General Specifications Change Notification (GSCN)

WR #	GSCN Name	Effective Date
19-059	Label and Barcode Placement for General Distribution (pallets and outer cases)	2 July 2019

Figure 6.7.2-1. Two (or more) identical barcodes

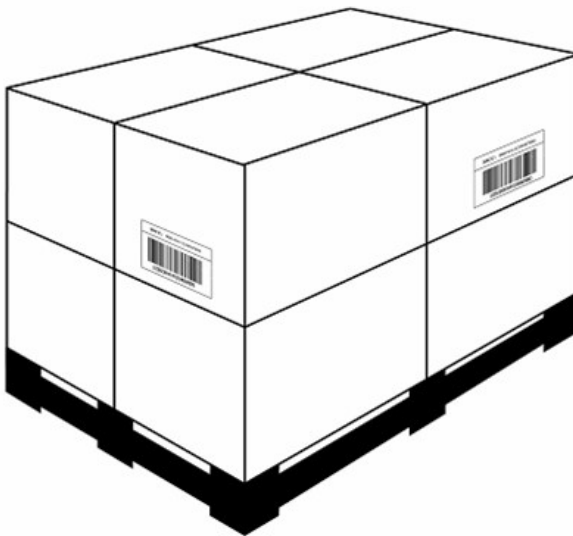
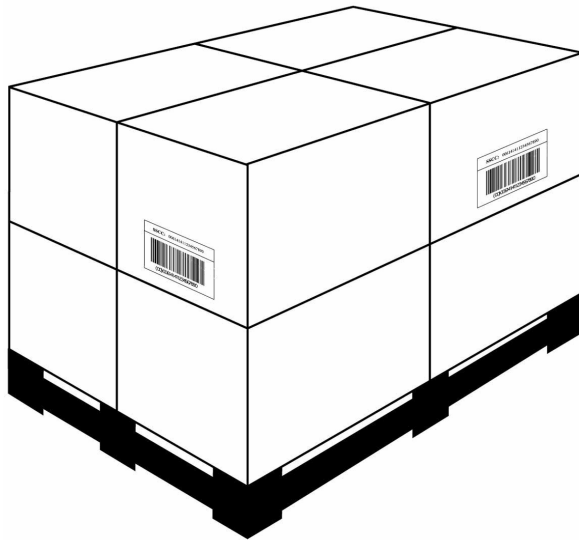
The GenSpecs state that units intended for general distribution shall have at least one barcode, and two are recommended when these symbols are pre-printed. In any relevant examples though labels are shown on the front and the right side, as in figure 6.7.2-1.

In addition the German user group would like to add a statement not to have two or more identical labels on one side of a logistic unit.

Although at least one side of all general distribution scanning items shall display the barcode information, it is recommended that two (or more) sides of the item carry a barcode with the exact same data when the following is recommended:

- The printing process makes this cost effective (e.g., pre-printed corrugated cartons). For outer cases or cartons (trade item groupings identified with a GTIN) it is recommended that the barcode is duplicated on a second side of the item when the printing process (e.g. pre-printing on corrugated cartons) makes this cost effective.
- For pallets (logistic units identified with an SSCC) it is recommended that two identical logistic labels are placed on adjacent sides. If possible one logistic label should be on one short side and the second identical logistic label on the adjacent right hand side as shown in the diagram below. The supply chain requirement is that one symbol is always visible (e.g., pallets that are stored either long or short edge facing).

Two identical labels improves scanning performance
